PROJECT/SITE OWNER: Bayside Development Partners II, LLC PROJECT ADDRESS: 600 Block of West Glencoe Place	PROJECT SUMMARY: New mixed occupancy 5 story building
--	---

VILLAGE CODE REVIEW

Date: November 4, 2022
To: Village of Bayside
From: Jackie Mich, AICP; Jeff Maloney; and Dean Proctor, AIA
Re: Building C – Architectural Review Committee Submittal

ONE NORTH - MULTIFAMILY BUILDING C

SIGNAGE ELEVATIONS

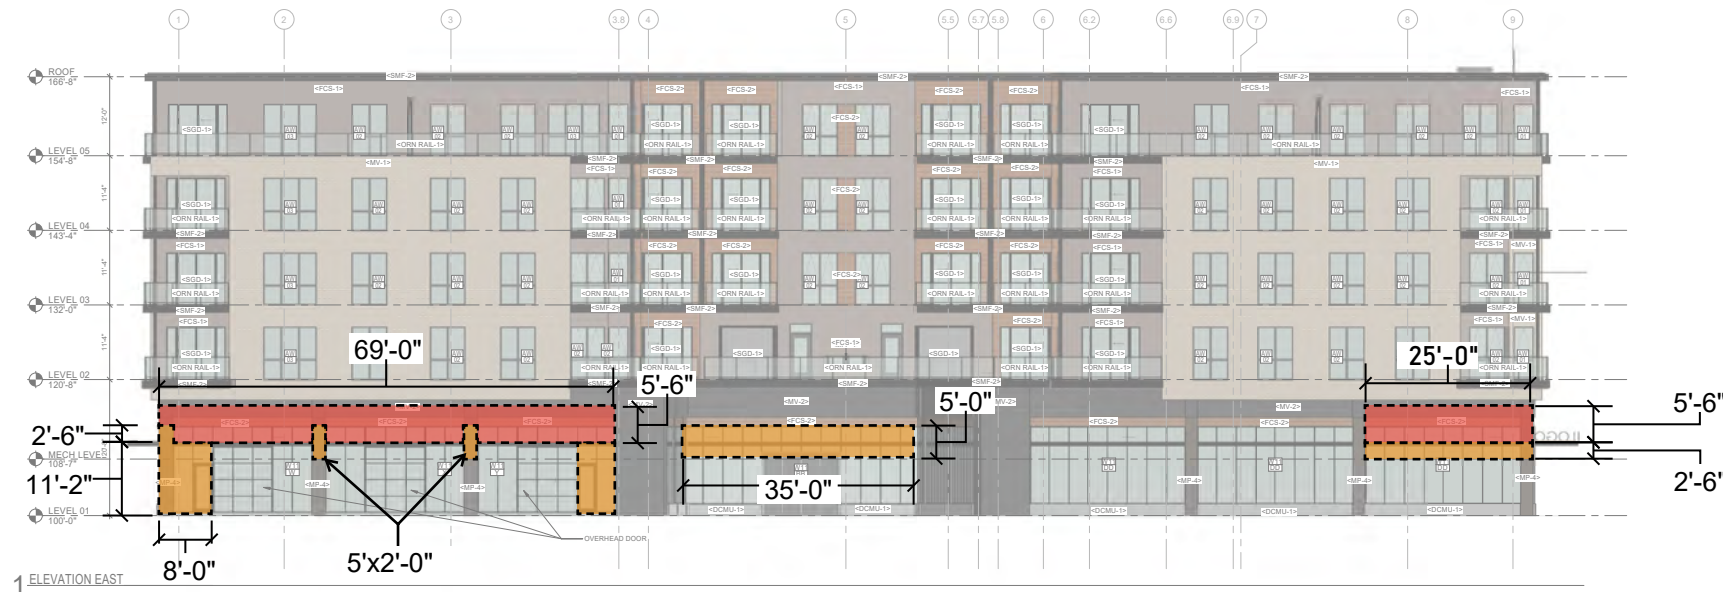
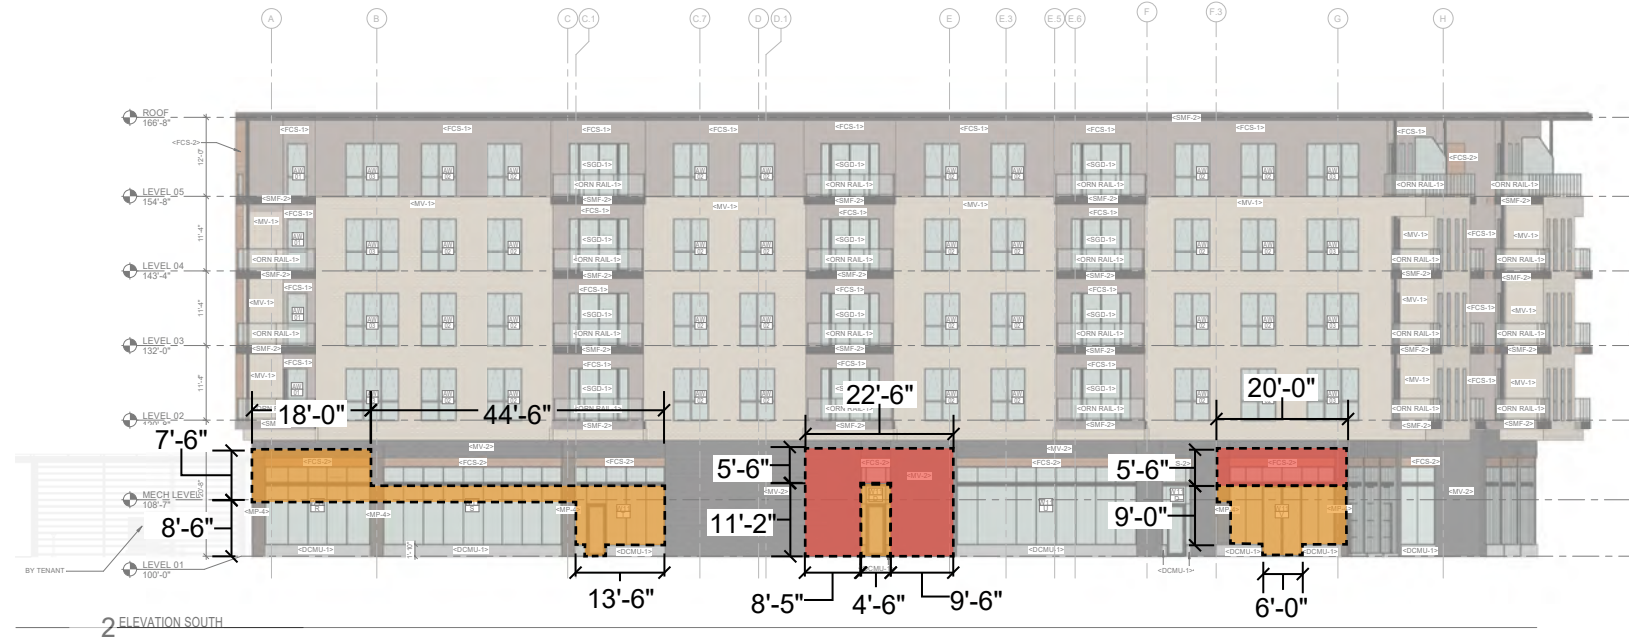
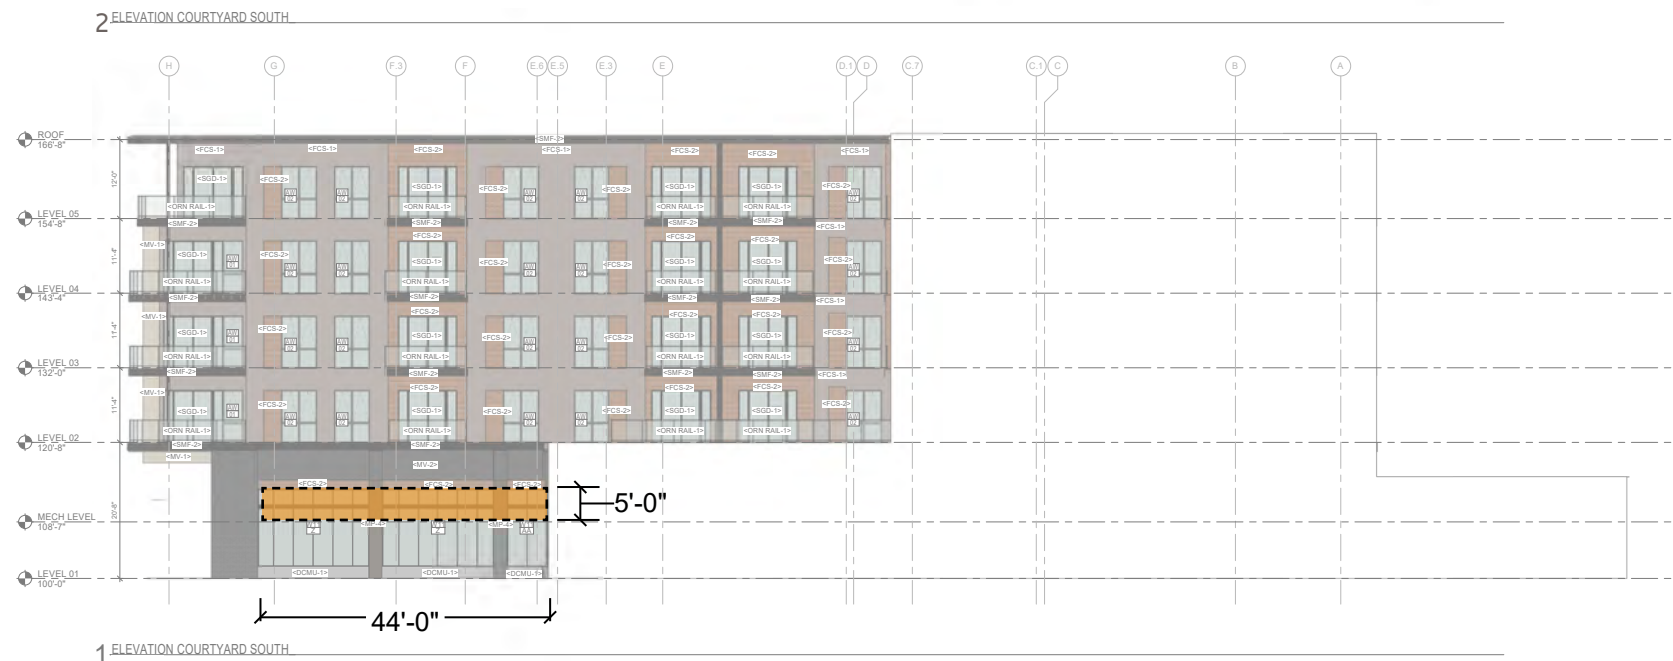
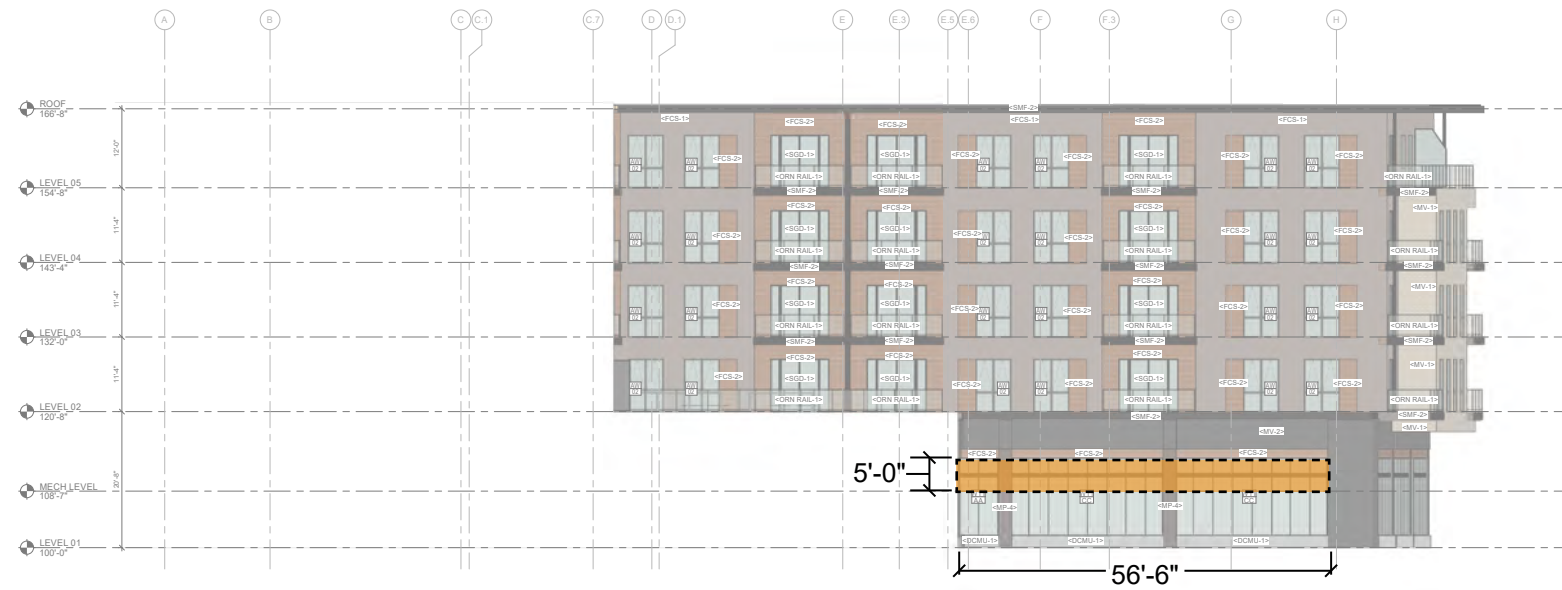
As for on-building signage, the submitted “Signage Elevations” identify primary and secondary signage zones on the first floor. Major entry tenant signs are to be limited to one column bay width per side. Sign permits will be reviewed and approved by the Village as tenants are finalized.

4. Add bicycle parking for at least 20 bicycles for library patrons and customers of the first floor uses.
5. Submit applications for sign permits for review and approval as tenants are finalized.
